# Access Compliance Report

## Public Rights-of-Way

### (Curb Ramps)

Intersection ID: 14746	Main Street: ALBEMARLE_RD	Cross Street: WILGROVE_MINT_HILL_RD	Location: SW
ADA ID: 1C2281B0256F	Ramp Type: Perp	Initial Pass/Fail: Fail	Overall Compliance: No
Codes/Mitigation Info/Possible Solution		Field Measurements/Component Compliance

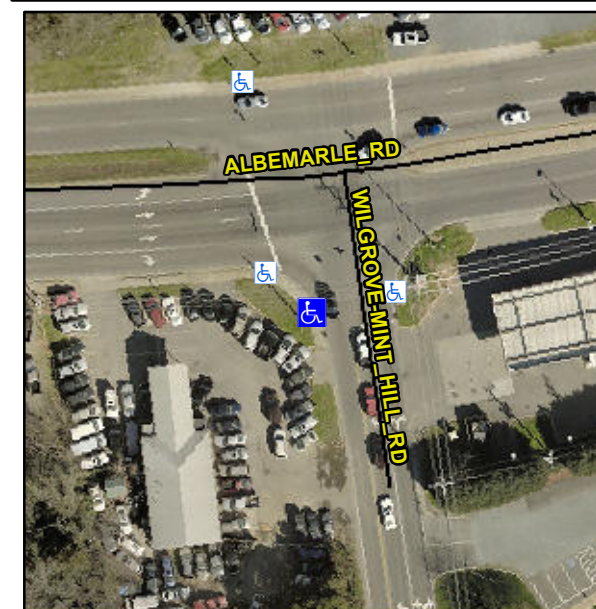
**Not Found, R304.5.1, R304.2.2**

Compliance	Description	Data	Compliance	Description	Data
N/A	Ramp Length (in)	58.0	No	Ramp Slope (%)	9.1
No	Ramp Width (in)	42.0	Yes	Ramp XSlope (%)	1.8
N/A	Flare Type LT	N/A	N/A	Flare Type RT	N/A
N/A	Flare Slope LT (%)	N/A	N/A	Flare Slope RT (%)	N/A
N/A	Flare Traversable LT?	N/A	N/A	Flare Traversable RT?	N/A
N/A	Landing Length (in)	N/A	N/A	DWS Provided?	N/A
N/A	Landing Width (in)	N/A	N/A	DWS Contrast?	N/A
N/A	Landing Slope (%)	N/A	N/A	DWS Length (in)	N/A
N/A	Landing X Slope (%)	N/A	N/A	DWS Full Width?	N/A
N/A	Landing Curb? (Y/N)	N/A	N/A	DWS Offset (in)	N/A
N/A	Shared Landing?	N/A			
N/A	Gutter Ponding?	N/A	N/A	Gutter Slope (%)	N/A
N/A	Gutter Lip Ht (in)	N/A	N/A	Gutter X Slope (%)	N/A
N/A	Painted X Walk1?	No	N/A	Painted X Walk2?	N/A
	X Walk 1 Direction	To E		X Walk 2 Direction	N/A
N/A	X Walk 1 Width (in)	N/A	N/A	X Walk 2 Width (in)	N/A
	X Walk 1 Slope (%)	0.8		X Walk 2 Slope (%)	N/A
	X Walk 1 X Slope (%)	1.0		X Walk 2 X Slope (%)	N/A

**Remove & Replace Entire Ramp.**
